April 2022 | Danfoss Climate Solutions for cooling

TECH INSIDER

Packaged Optyma™ Condensing Unit FH → FH² Compressor Change

Optyma Plus new lay out

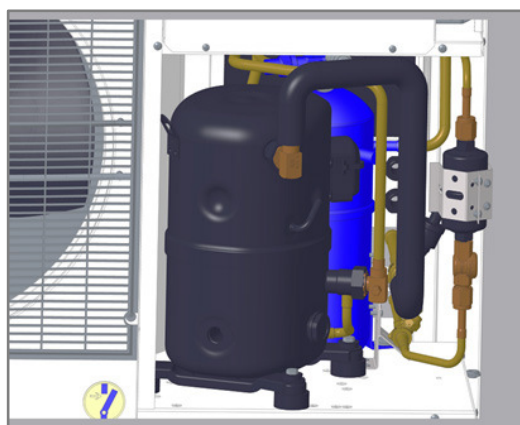
Changed technical features, tubing, and wiring of the condensing unit:

- Better cooling capacity +12 %
- Better COP +1 %
- Similar noise level
- Changed internal wiring diagram due to internal compressor capacitor change

AK-CC55 SC (UI) SW Update 1.70

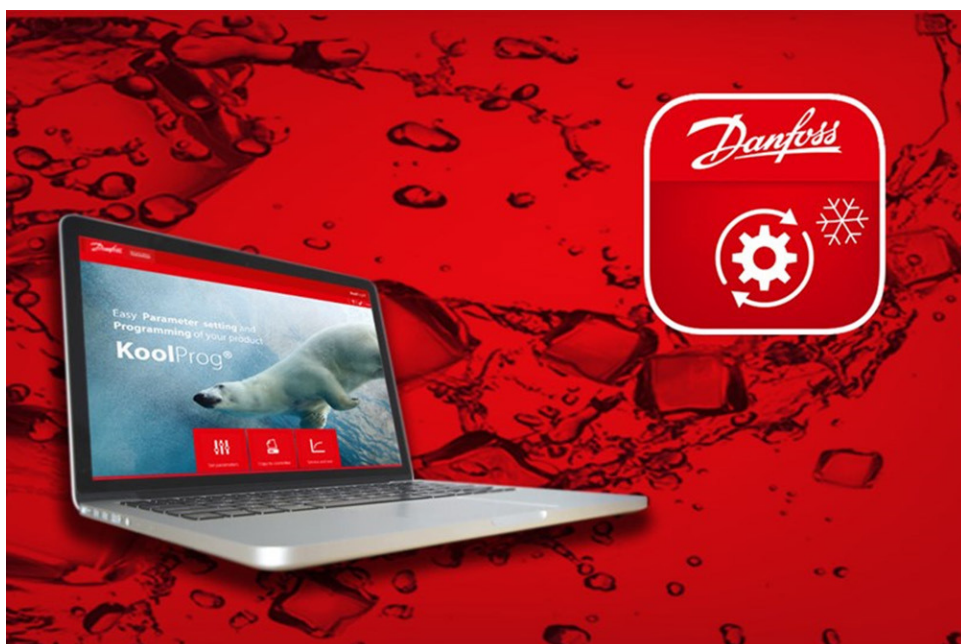
New features and functions:

- Extension of thermostat range from -50 °C down to -60 °C
- Function to remote lock display keypad (type AK-UI55 Set)
- Possibility to stop fan only when door opens (refrigeration still active)
- Improved SH-close control when running modulating thermostat (MTR)
- Separate defrost/thermostat parameters for thermostat band 2
- Option for user defined temperature sensors type for S3, S4 and S5
- Improved melt function when running modulating thermostat (MTR)
- Oil flush function to force oil back to the compressor/oil receiver
- Option for offset adjustment for sensors S2 and S5 with long cable runs
- Minimum defrost time added to be used in CO₂ hot gas defrost applications

Product version identifier which is shown on the packaging label and product label on the front cover below the code number will be stepped up from PV03 to PV04.
